STAFF RECOMMENDATION 1501 Beechwood Avenue August 15, 2012

Application: New Construction—addition
District: Belmont-Hillsboro Neighborhood Conservation Zoning Overlay
Council District: 18
Map and Parcel Number: 11801000600
Applicant: Betsy Pogue
Project Lead: Melissa Baldock, melissa.baldock@nashville.gov

Description of Project: Application is to construct a one-and-a-half story rear addition that is wider than the historic structure.

S 1 . 1
S I T E P L A N
2 5 J U L Y 2 0 1 2
C O N S T R U C T I O N D O C U M E N T S

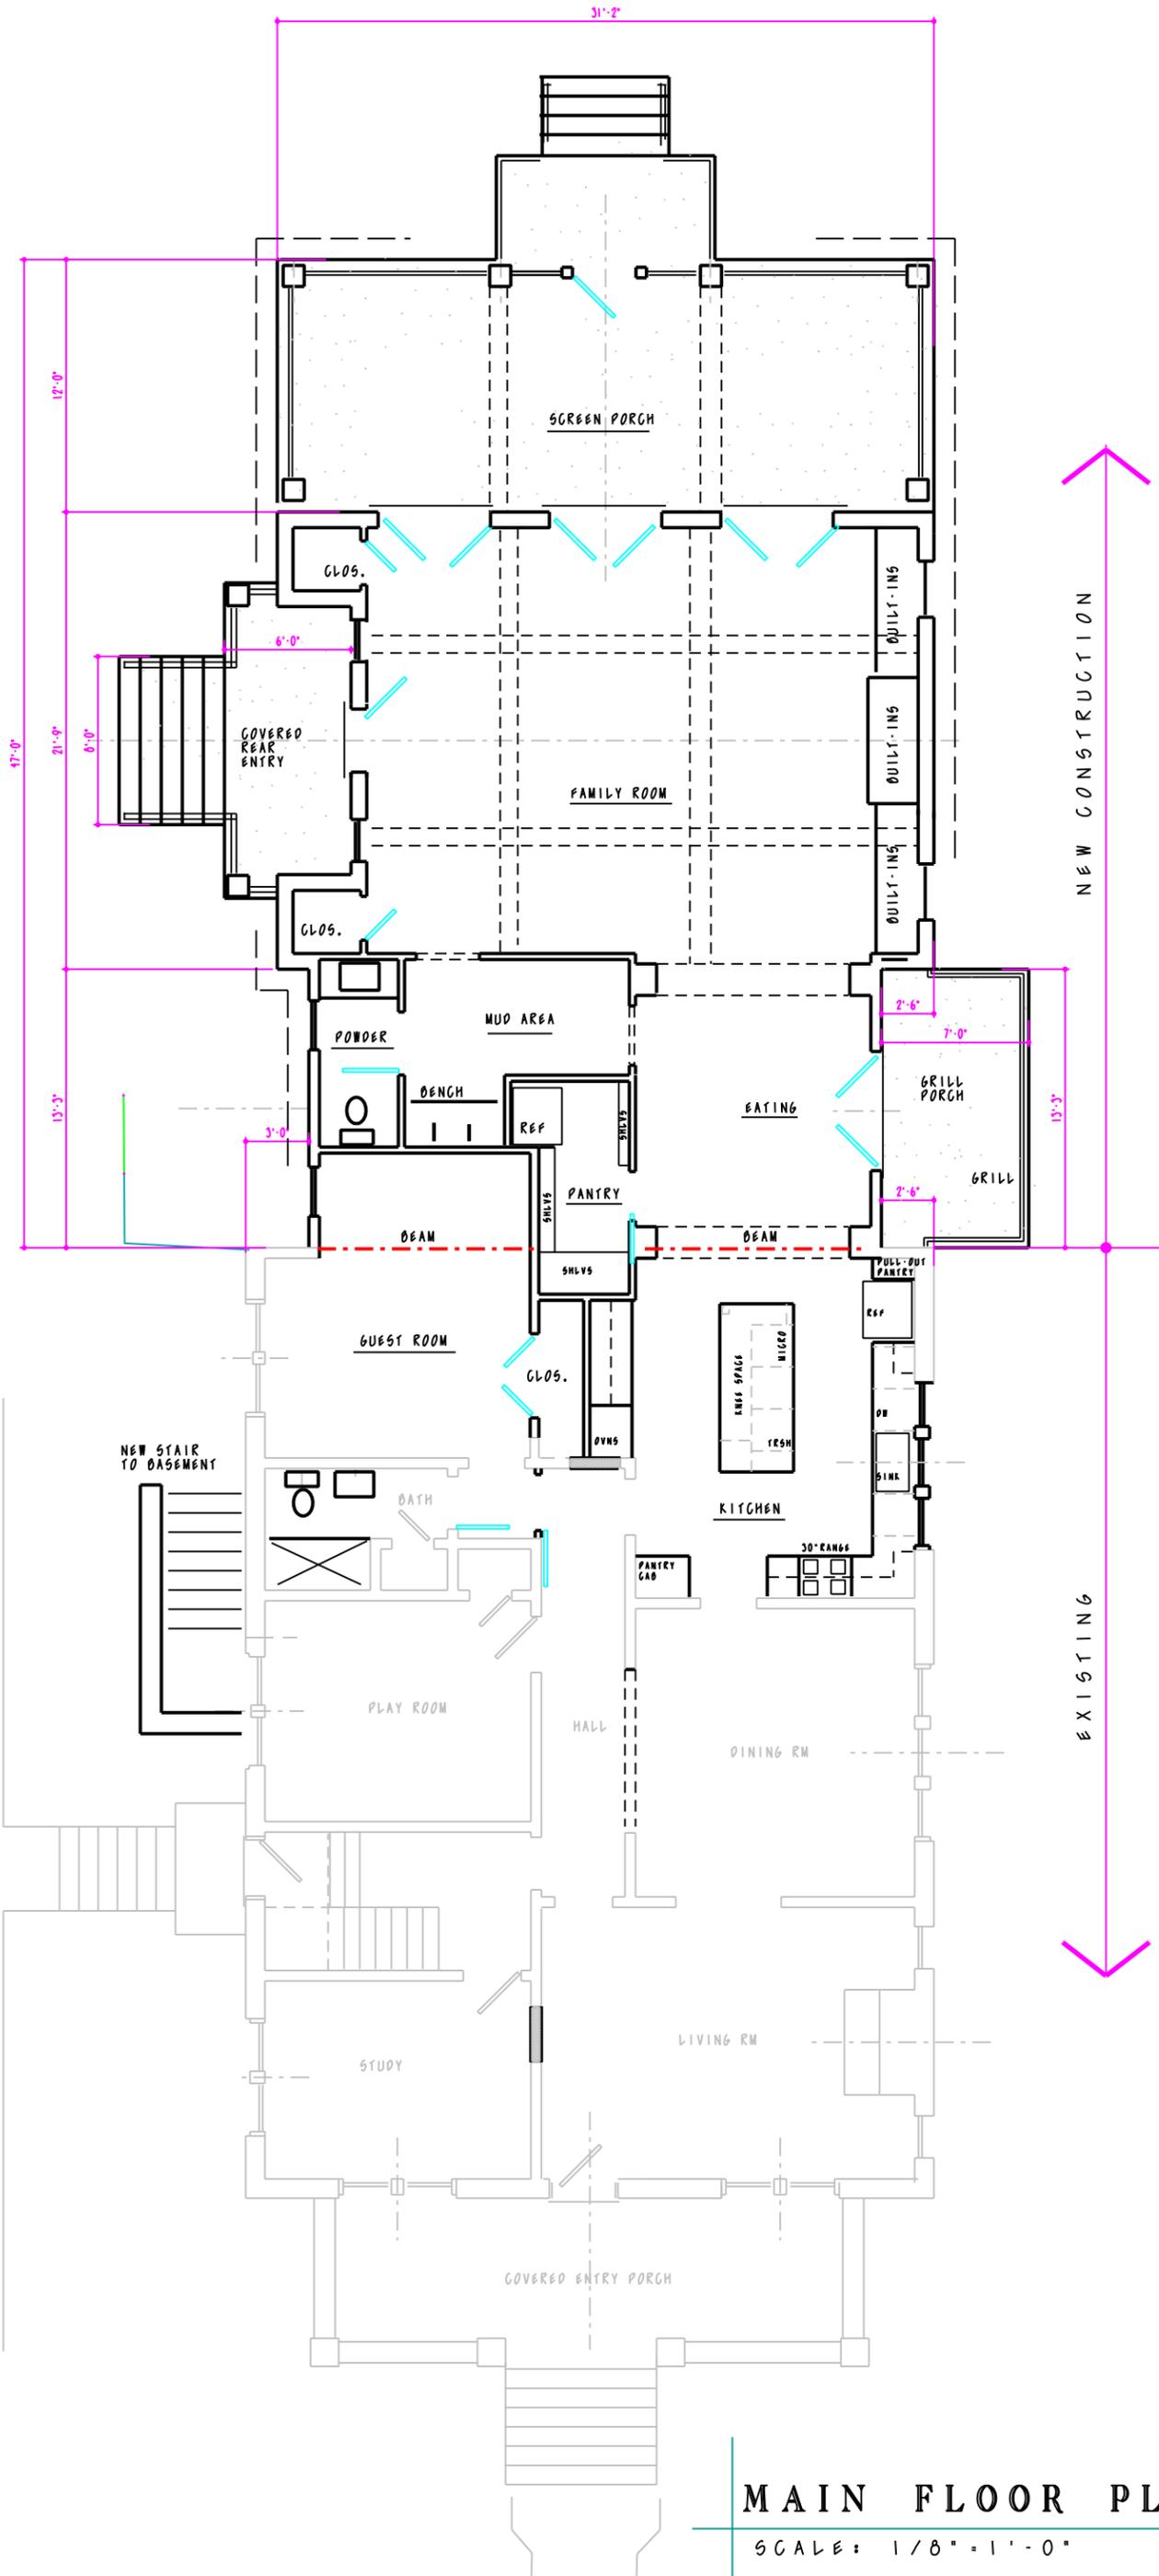
Location and Setback: 1501 Beechwood Avenue is a corner lot, located at Beechwood Avenue and 15th Avenue South. The proposed addition’s left (15th Avenue South) façade will therefore be highly visible. The addition will be located behind the historic house, although it does extend one foot (1’) wider than the historic house for a depth of fifteen feet (15’) (to be discussed in more detail under the “Height and Scale” section).

The addition meets all base zoning requirements for setbacks. On the right façade is an uncovered deck which extends beyond the five foot (5’) side setback line. On the left (15th Avenue South) façade are uncovered steps off the addition and off the historic house which encroach on the required ten foot (10’) side setback for a corner lot. In a

neighborhood conservation zoning overlay like Belmont-Hillsboro, the Metro Historic Zoning Commission does not review uncovered decks or uncovered stairs. Therefore no setback reduction is being considered under this application. The issue of the location of the deck and the stairs is one that should be addressed by the Codes Department. The Codes Department has indicated to the applicant that if the features are constructed of non-combustible materials, they can encroach upon the side setbacks.

Given that no setback reduction is required, staff finds the location and setbacks of the proposed addition to meet Section II.B.1.c. and II.B.2.a. of the *Belmont-Hillsboro Neighborhood Conservation Zoning Overlay: Handbook and Design Guidelines*.

ROOF PLAN

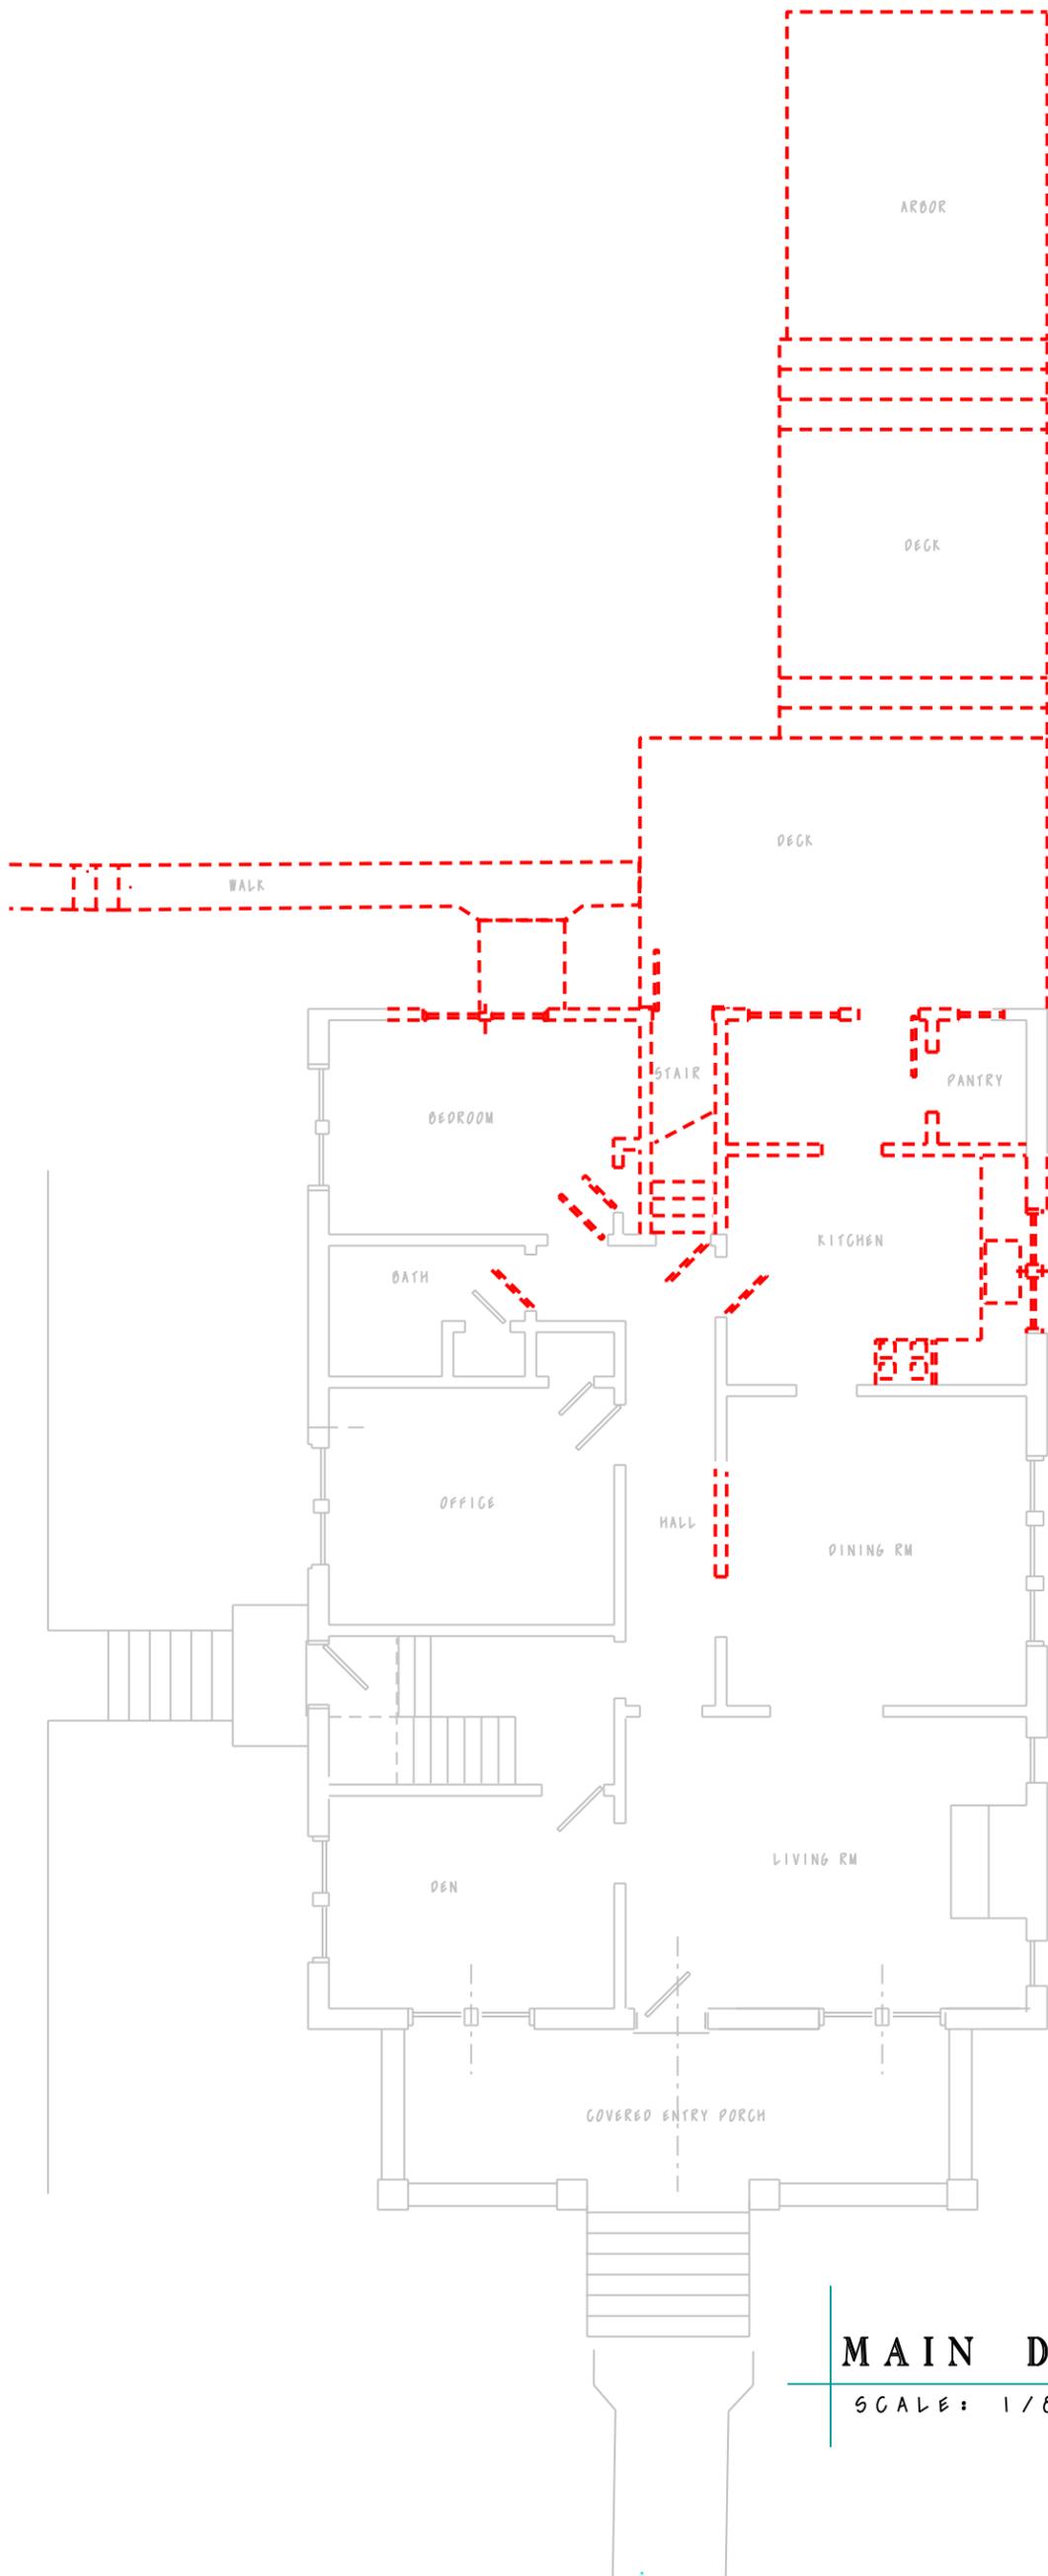
Roof: The historic house has a side gabled roof form with a slope of 8/12. The addition's roof will tie into the back of the house with a gable that also has a slope of 8/12. The wider and taller portion of the addition will have a gabled form with an 8/12 pitch. The addition incorporates several dormers, including new shed dormers with a 3/12 slope off the back roof of the house and off the right side of the alcove section of the addition; and two gabled dormers with an 8/12 slope off of the wider portion of the addition. All of these dormers meet the design guidelines in terms of their scale, proportions, and locations.

Staff finds the addition's roof pitches and forms to meet Section II.B.1.e. and II.B.2.a. of the *Belmont-Hillsboro Neighborhood Conservation Zoning Overlay: Handbook and Design Guidelines*.

UPPER LEVEL DEMOLITION PLAN

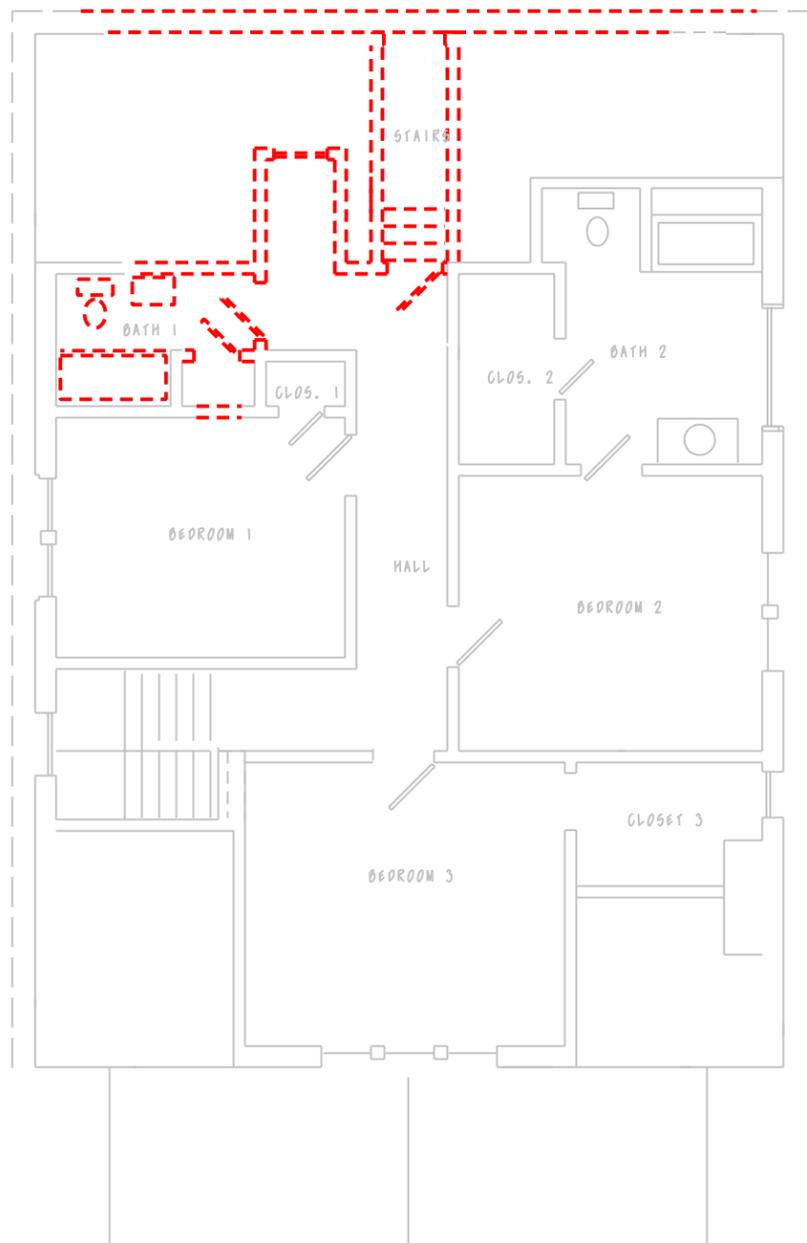
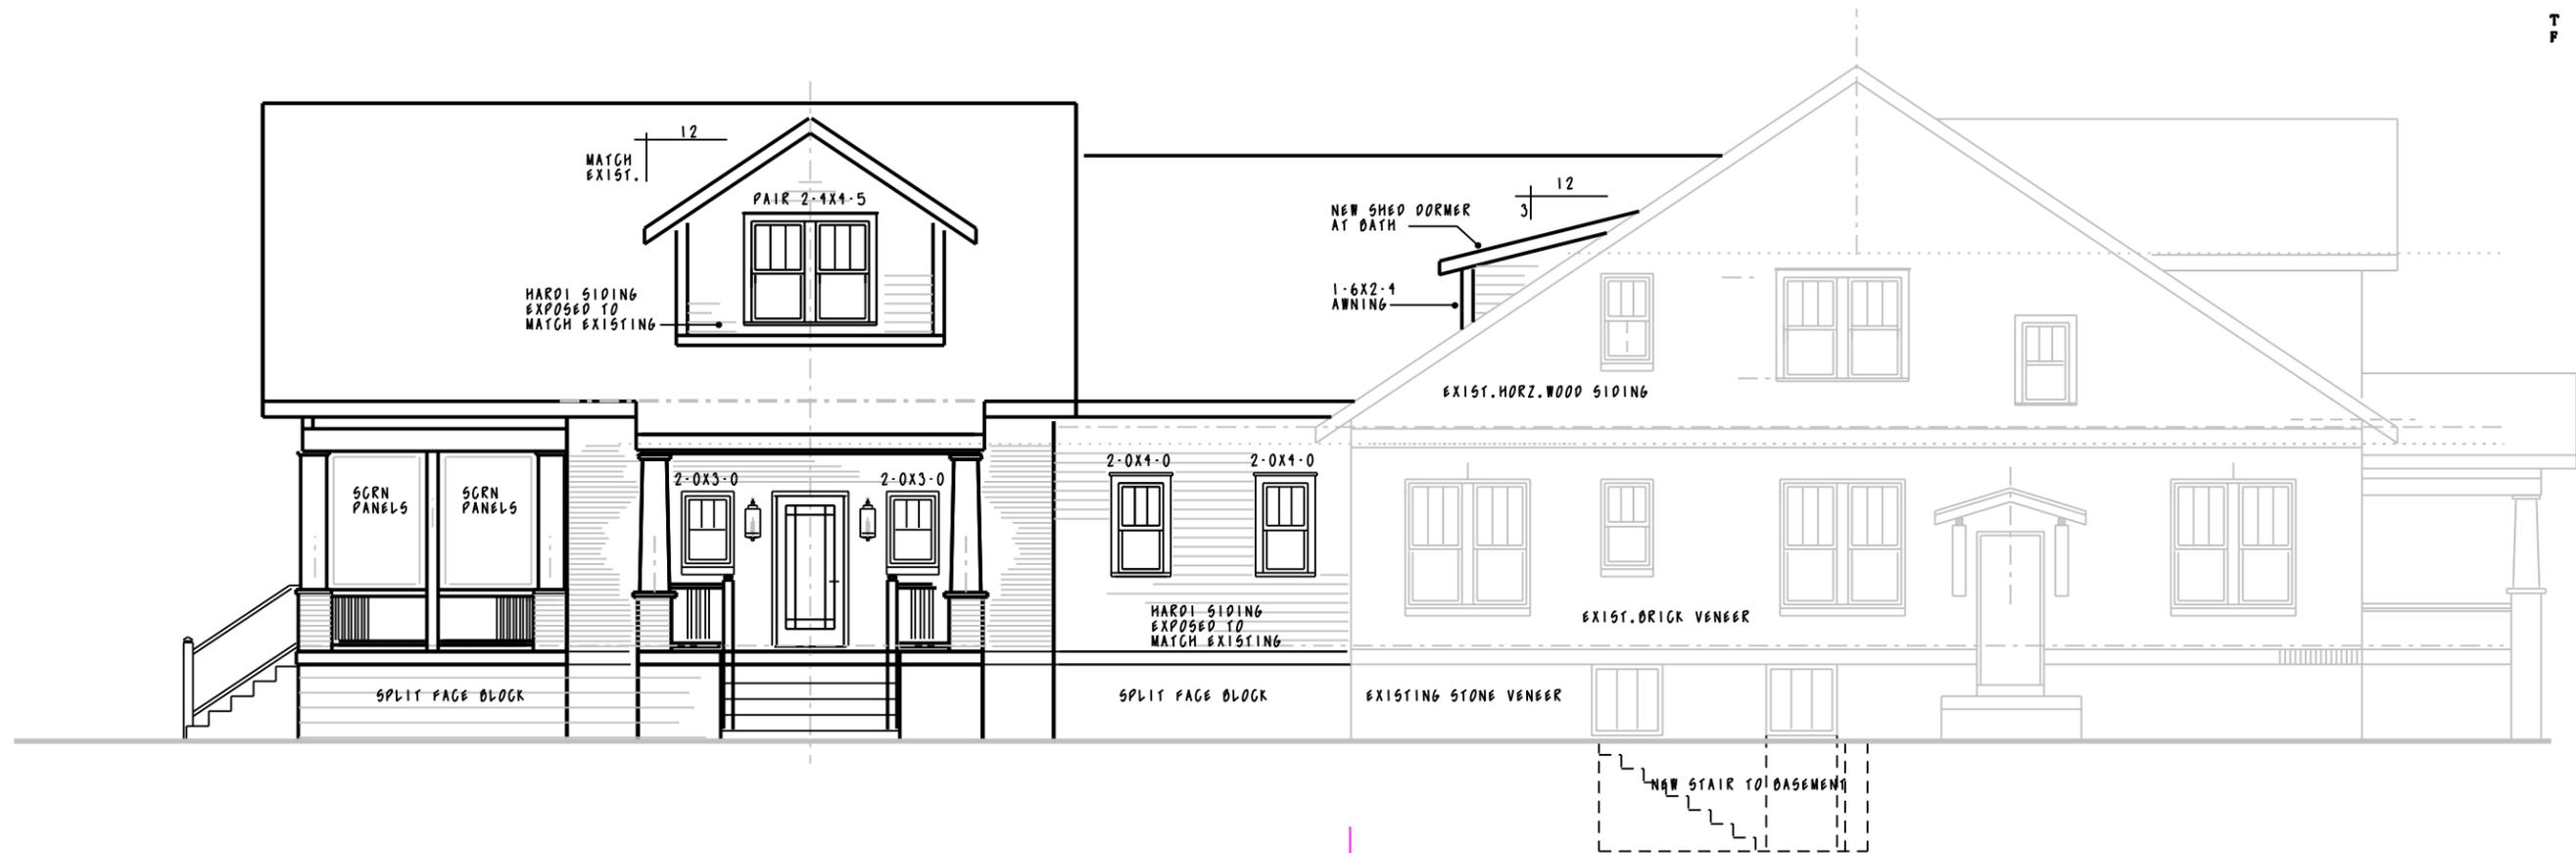
Partial Demolition: The addition will require the removal of the majority of the rear wall but will retain the corners and the original roof form, which would allow the addition to be removed without negatively affecting the form and integrity of the original building. A portion of the side wall will be demolished to accommodate a new window. Since this is a secondary elevation, and the alteration happens on the rear portion of the side wall, the change will not alter the character of the home. All existing materials are planned to be retained.
